This letter is to request a review of several changes planed to the Metorex SIPS probe which is currently covered by Registry NR-0701-D-104-B. These modifications are in the latter stages of design and evaluation but have not yet been formalized. These changes will be implemented in the fall of 1999 and will occur in all probes. Thus, these modified probes will be identified by a serial number greater than a certain number that will be determined at a later date.

## **Modifications to SIPS Probe NR-0701-D-104-B**

NO.: NR-0701-D-104-B

Attachment 1A

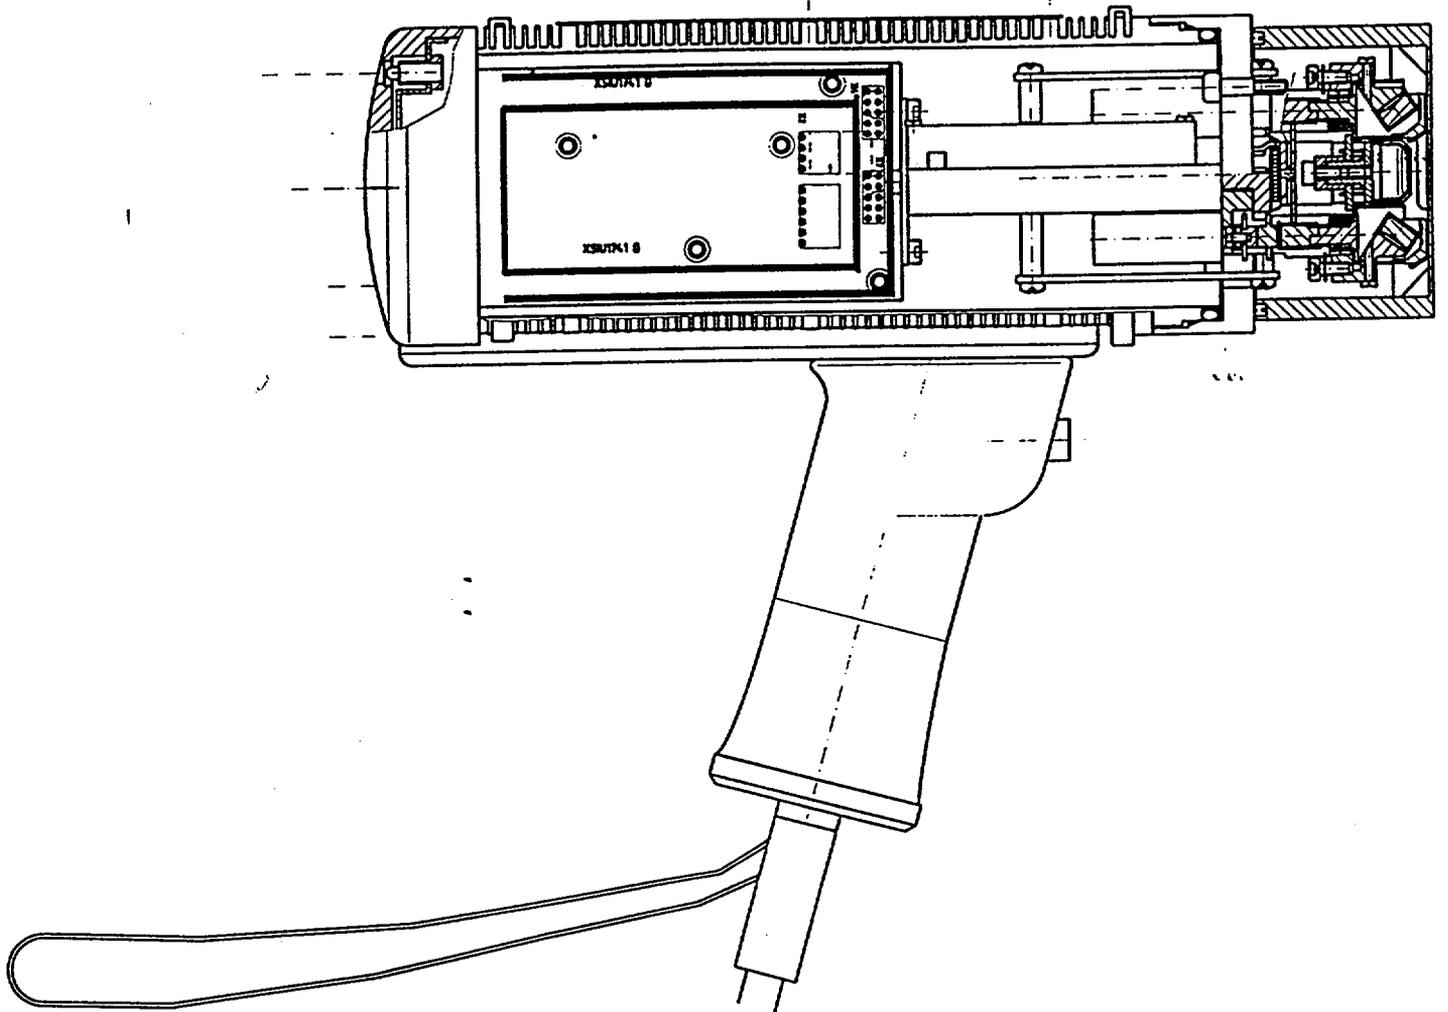
Attachment 1A (p3) is a drawing of the redesigned probe. Two external modifications have been made to the probe. First, three of the grooves in the body of the probe have been eliminated. This provides a more secure mounting for the screws that hold the radiation warning label. The second change is that a new handle has been designed which better fits the grip and includes a safety strap to minimize the chance of dropping the probe. In addition, the probe cable now enters the probe through a connector rather than being hard wired to the probe.

# Attachment 2A

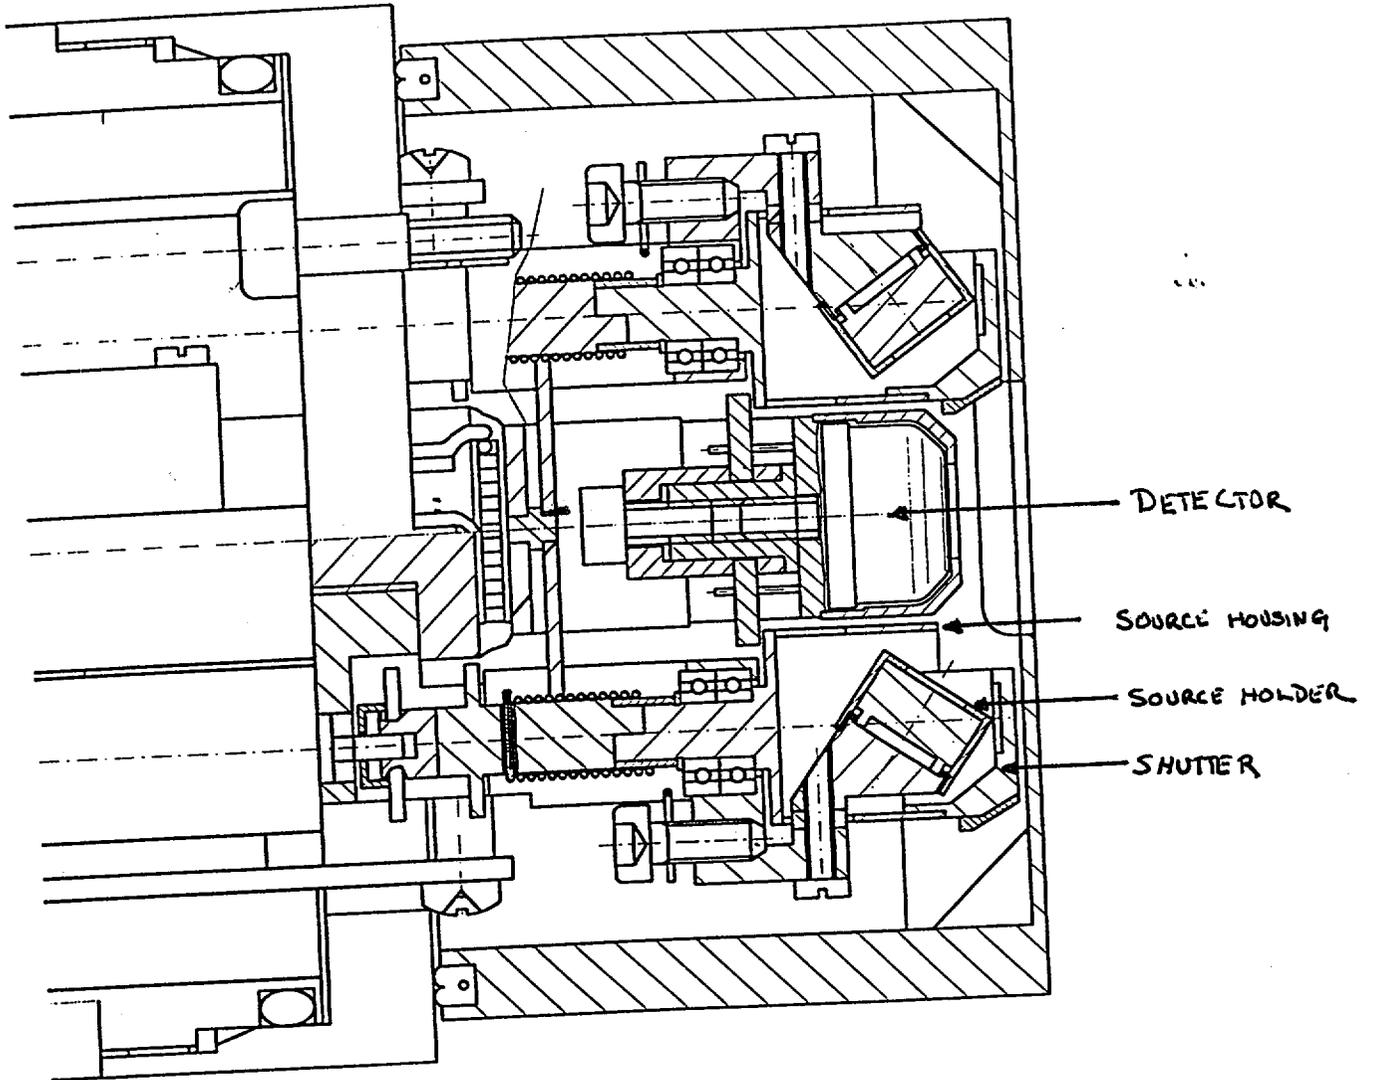
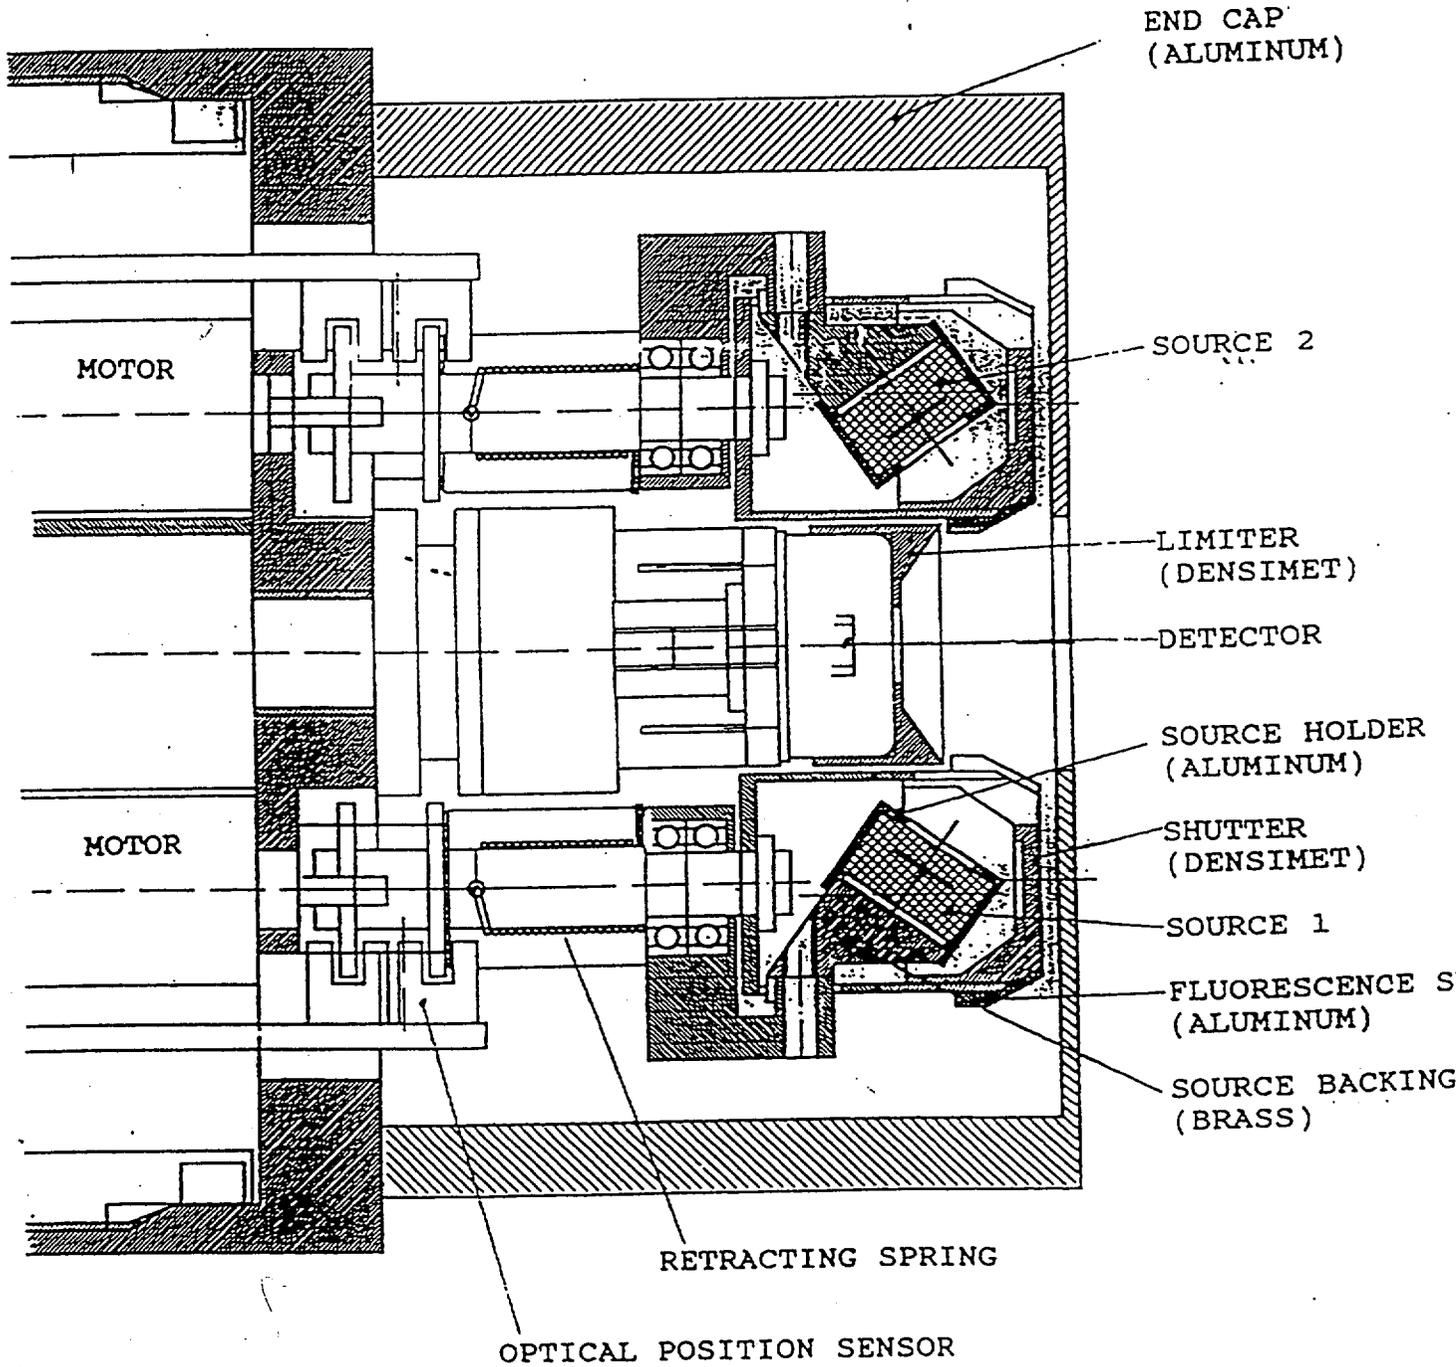
Attachment 2A (p4) shows the modification of the detector geometry. In this view, the lower shutter is opened and the upper shutter is closed. When compared to Attachment 2 (p5) from the registry, the change in the position of the detector can be seen. The detector is much closer to the front of the probe. In order to shield the detector from the source, the source housing has been modified slightly (p6). Thus, the shutter opening is slightly smaller than in the original probe. Otherwise, no changes have been made to the source holder and/or the shutter mechanism.

Source Housing  
 Suliinkansi

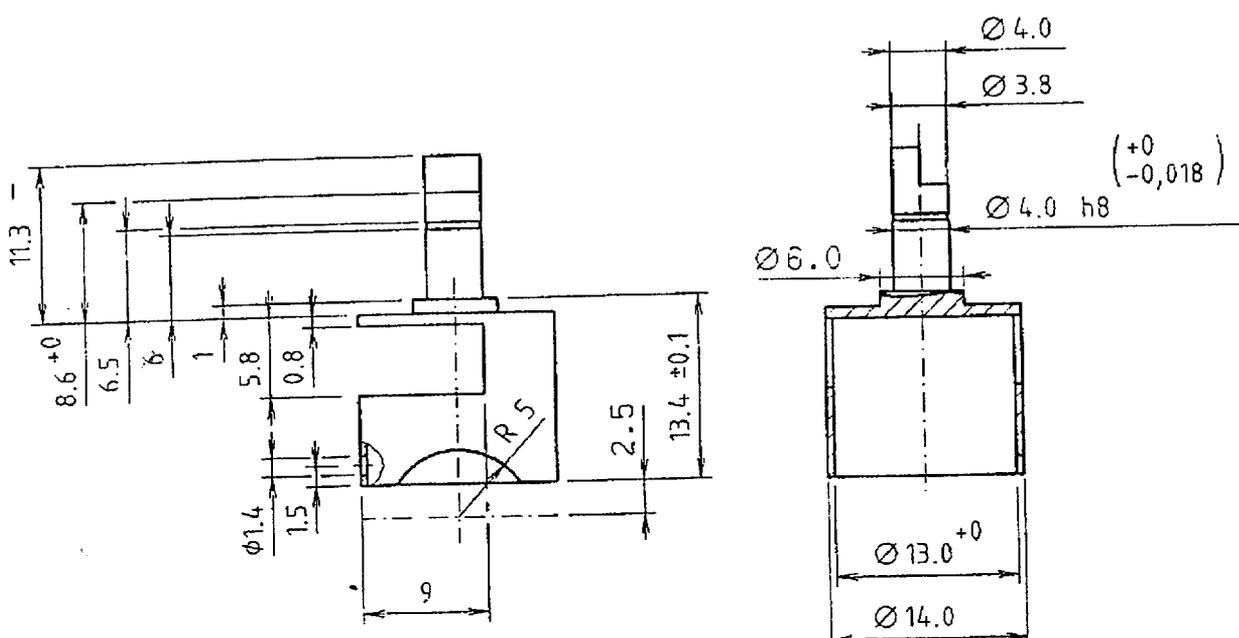
↑  
*This machining is left away from the new SIPS.*

# Attachment 3A

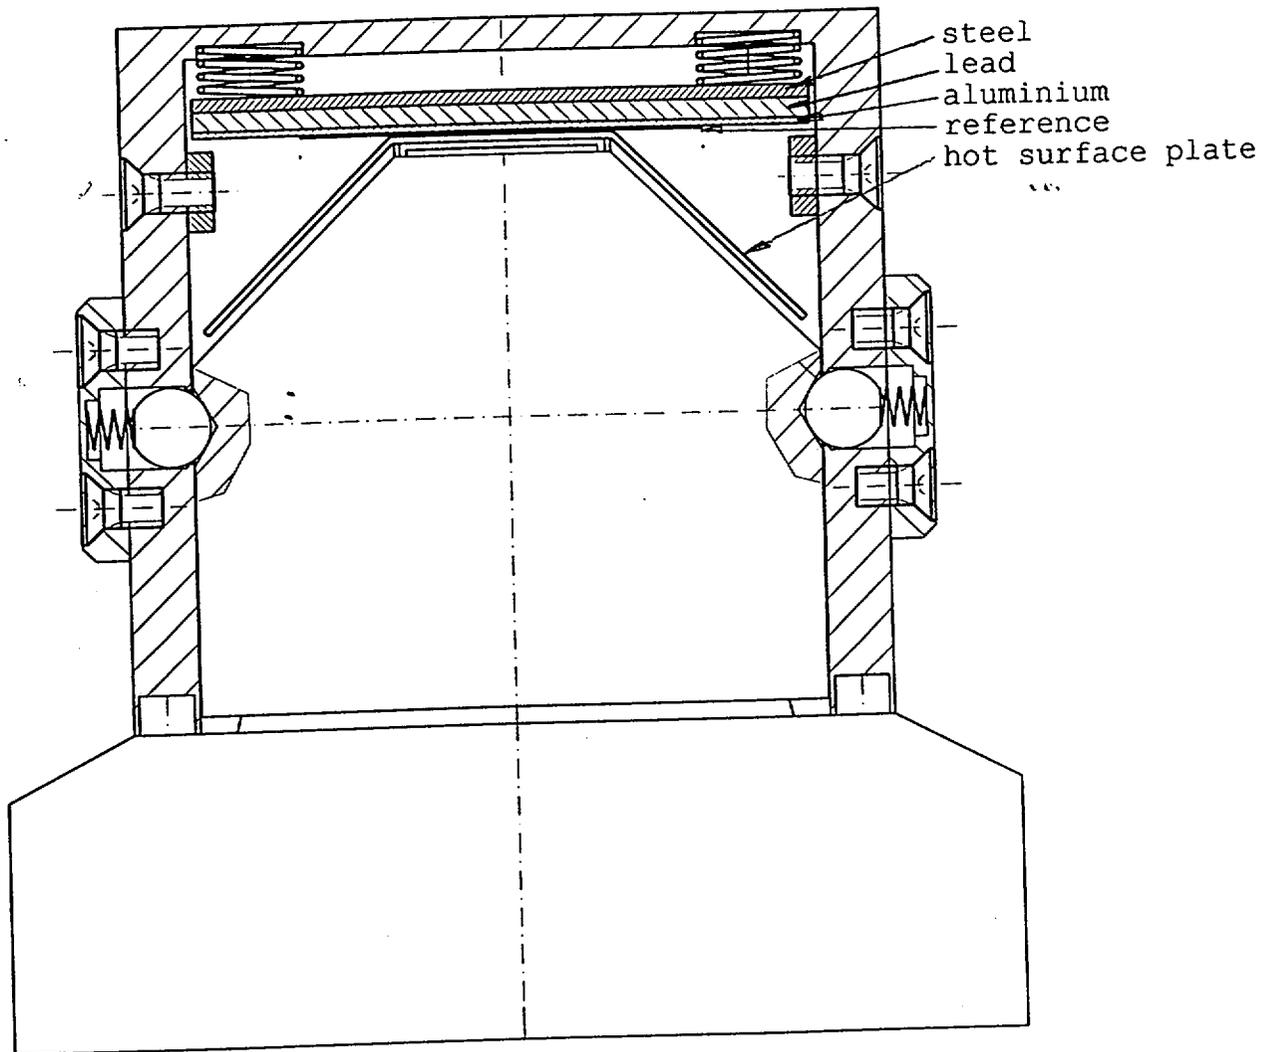
Attachment 3A (p7) illustrates the new heat shield and end cover. The heat shield (Attachment 4; p8) is an option for the unit to allow the probe to be used at elevated temperatures. The shield and associated mounting slightly separate the probe from the sample and provide some insulation. The installation of the heat shield slightly extends the length of the probe snout. Thus, with and without the shield, the probe snout will be of different lengths. This has led to the development of a new end cover. In this version, the cover is fixed onto the probe snout with two spring loaded balls in the side of the cover. These balls fit into the small conical recesses in the probe snout. The cover is slightly longer than the old version and shielding mechanism is floating on four (4) springs. Two (2) bars on the side of the cover limit the outward movement. The same cover is used with or without the heat shield. The shielding mechanism is sandwich composed of a lead sheet between a steel and aluminum sheet. A copper reference sample is attached to the front of the sandwich. The steel plate adds to the shielding provided by the cover when compared with the previous cover.

FIGURE 1b. LOCATION OF DOSE RATE MEASUREMENT POINTS

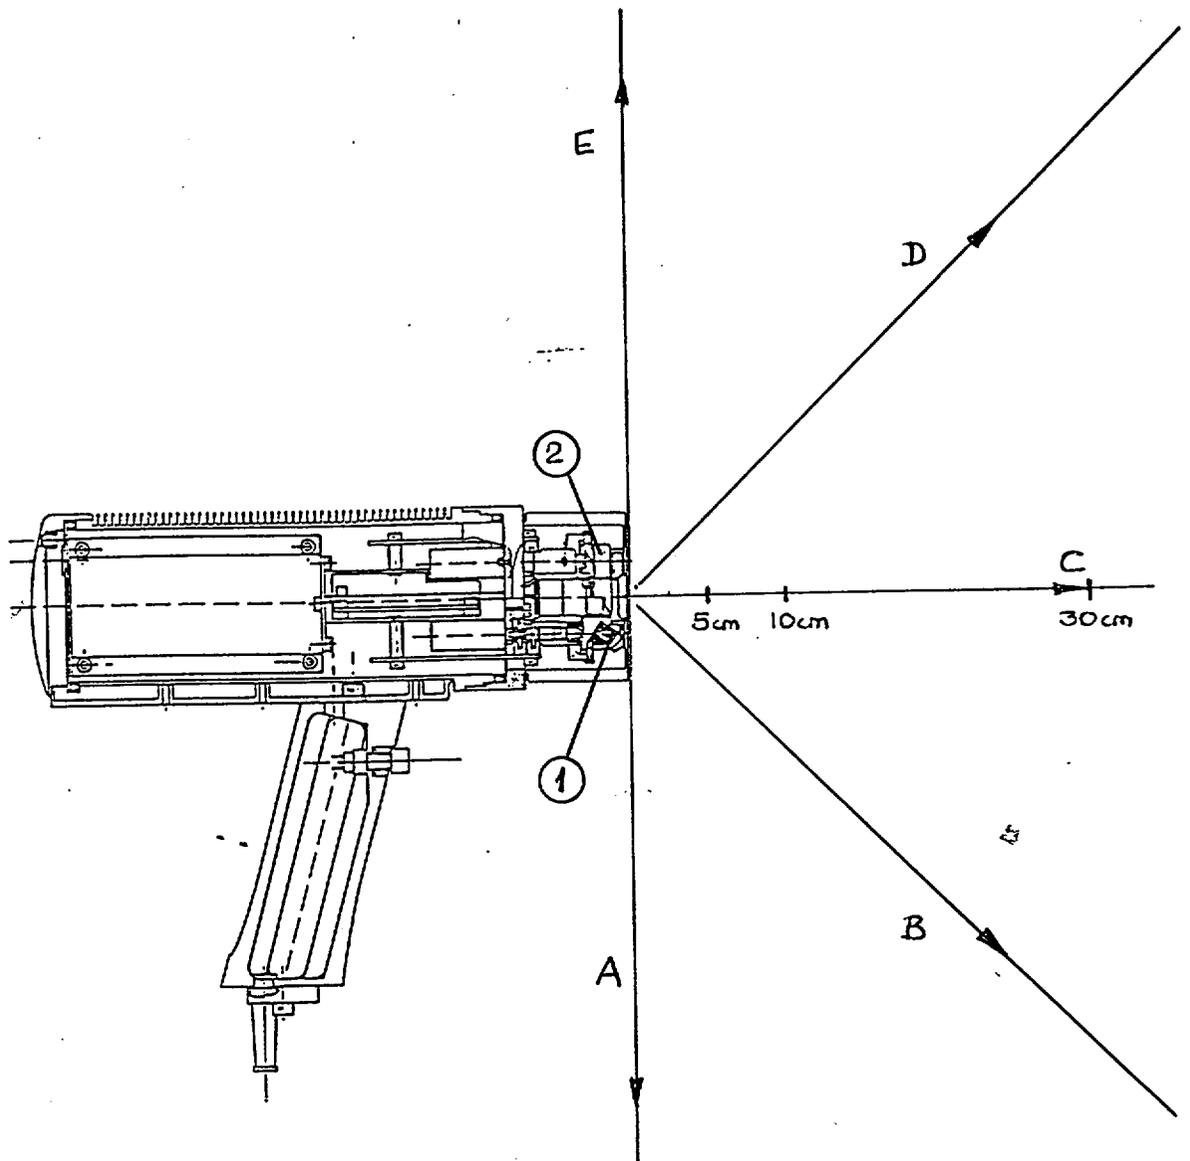
In order to determine the effect of these changes on the radiation profile, measurements were made using the same Cd-109 source in both the current designed probe and the revised probe. Cd-109 was chosen as it has the highest radiation profile in the testing of the original probe. The measurements were made using a Giger counter to monitor the primary beam. A scintillation detector was used to measure the weak radiation in other directions. The following comparative table shows the radiation along the axis illustrated in figure 10 (p9):

These profiles indicate that there is essentially no difference in the radiation profiles of the two designs.
